**Author:** Henrik Sondell, Technical Support  
**Date:** 2004-03-09  
**Subject:** GSM Triplets Rev. A PCB - ESD Improvement  
**Rating:** Level 1&2 Authorized

**Products:** V300 (SUGxxxxAA)  
V500, V525, (SUGxxxxAA or SUGxxxxBA)

Diagram 1.0 New (0188940N02) Rev. E SIM Chassis Design

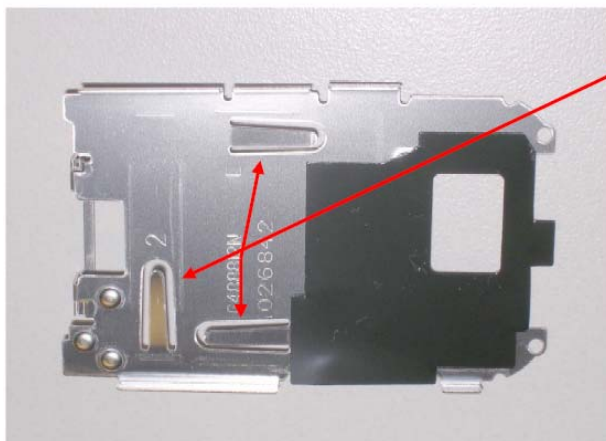
**Problem:** Service is aware of a field issue, identified during the 1st 200 NPI Analysis on the affected models listed above. Some units, returned with a customer complaint of "Invalid Battery", were found to exhibit a lower than normal resistance on the OWB Line to the Neptune IC. Analysis revealed the root cause of this failure to be damage to the Neptune IC induced by ESD. Product Development identified, prior to launch, that all Triplets Rev. A PCB's had a high susceptibility ESD related failure due to insufficient grounding of the SIM Chassis. A short-term corrective action was implemented, on all shipping product, adding a conductive 1.5mm pad to the back of the SIM Chassis to effectively ground the chassis. Unfortunately, after time in the field, the conductive pad can compress to the point where it no longer makes contact with the PCB Shielding thus leaving the phone susceptible to ESD related failure.

**Solution:** A re-design of the metal SIM Chassis (0188940N01) has been implemented in production as of 1/26/2004. The new (0188940N02) Rev. E design includes three metal fingers that extend into the housing and make contact with the PCB Shielding adequately grounding the SIM Chassis. For additional ESD Protection, a diode was added to the Rev. D PCB release.  
**Note: Also contained in the new Rev. E design is an improvement for connectivity of the Flip Assembly to PCB connector. See Service Bulletin NB\_SB006.**  
Diagram 1.0 below shows a sample of the (0188940N02) Rev. E SIM Chassis with the improved design.

**Special Note:**  
New Design with Three Metal Fingers to GND Chassis

1. Disassemble the unit
2. Remove the existing Poron Pad from the Flip Assembly Connector  
See *NB\_SB006*.
3. Replace the existing metal SIM Chassis with the improved Rev. E Design

**Diagram 2.0**

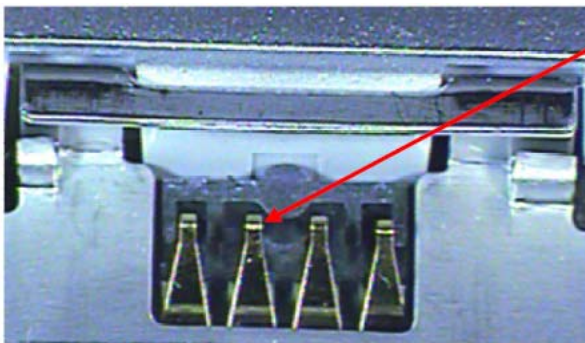
1. Power up the unit through the CE Connector with the battery removed
  2. Probe the voltage on the OWB Line at M1700 (pin 3). The Voltage should be 2.7 VDC and will measure significantly less (approx 0.7 VDC) on failures with a damaged Neptune IC. See Diagram 2.0 below.

**OWB Line:**  
M1700 Pin 3 = 2.7VDC

- a. If the voltage on the OWB line is correct, then the fault is not related to this issue and normal troubleshooting techniques should be applied to the battery and the unit to determine the failed part.

3. Once a damaged Neptune IC has been confirmed the failed board should be swapped.
